Appl. No. 10/699,617

Amdt. dated March 15, 2005

Reply to Office action of December 15, 2004

REMARKS

Markup Sheet

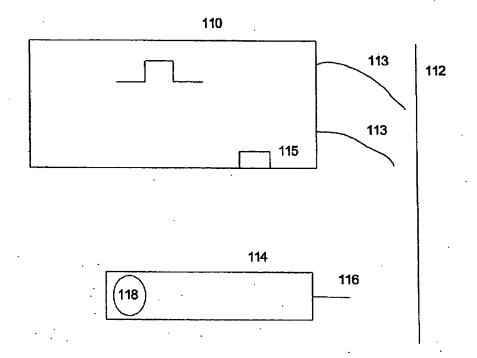
Please amend FIG. 5 as indicated herein to add the label "Prior Art". A markup and replacement sheet are provided.

The Examiner requested that FIG. 5 be labeled as "prior art". Applicant's representative thanks the Examiner for noting this oversight on our part. Drawing amendments to add the prior art label to FIG. 5 are submitted herewith.
